- **NOISE/VIBRATION—WHEN DRIVING IN 4X2 MODE WITH HUBS LOCKED—4X4 MODELS**
- **DRIVELINE—VIBRATION/NOISE—WHEN DRIVING IN 4X2 MODE WITH HUBS LOCKED—4X4 MODELS**

**Article No.  
97-13-22**

**FORD:** 1987-1996 BRONCO, F-150, F-250 LD  
1987-1997 F-250 HD

Figure 1 - Article 97-13-22

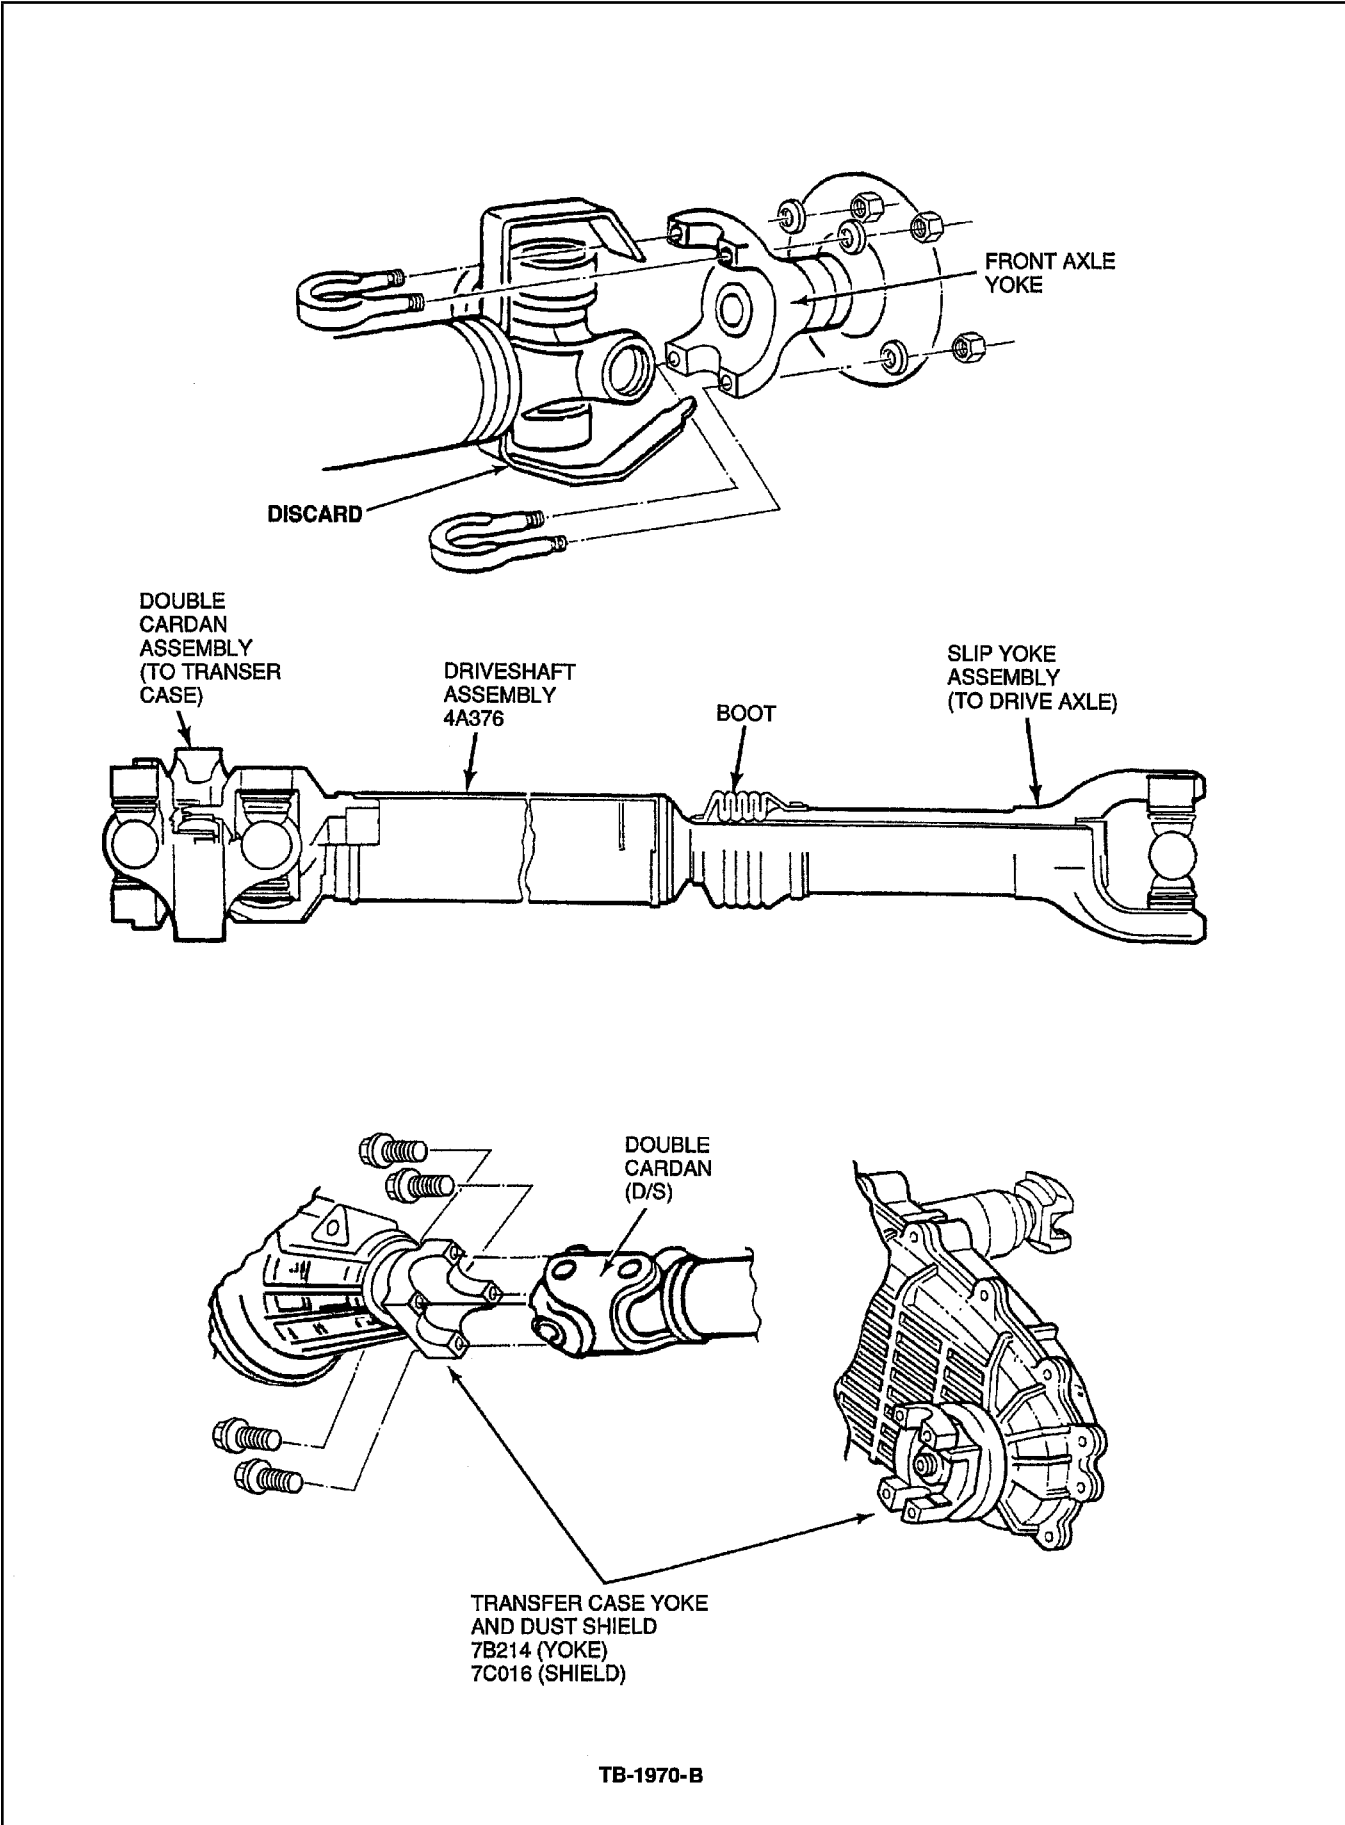
Replace the front driveshaft with one that has a double cardan joint at the transfer case and a compatible companion flange for the transfer case. Refer to the following Service Procedure for details.

1. Install the double cardan yoke on the transfer case front output shaft. Place the slinger, rubber seal, steel washer, and locknut on the output shaft. Tighten the nut to 203-244 N•m (150-180 lb-ft).
2. Install the front driveshaft.
  - a. Position the double cardan U-joint end of the driveshaft to the transfer case front output yoke.
  - b. Install the four (4) bolts, Figure 1.

3. Install the driveshaft to the front axle yoke using two (2) U-bolts, four (4) washers and nuts, Figure 1.
4. Tighten the bolts at the transfer case to 27-38 N•m (20-28 lb-ft). Tighten the nuts at the front axle to 11-20 N•m (8-15 lb-ft).
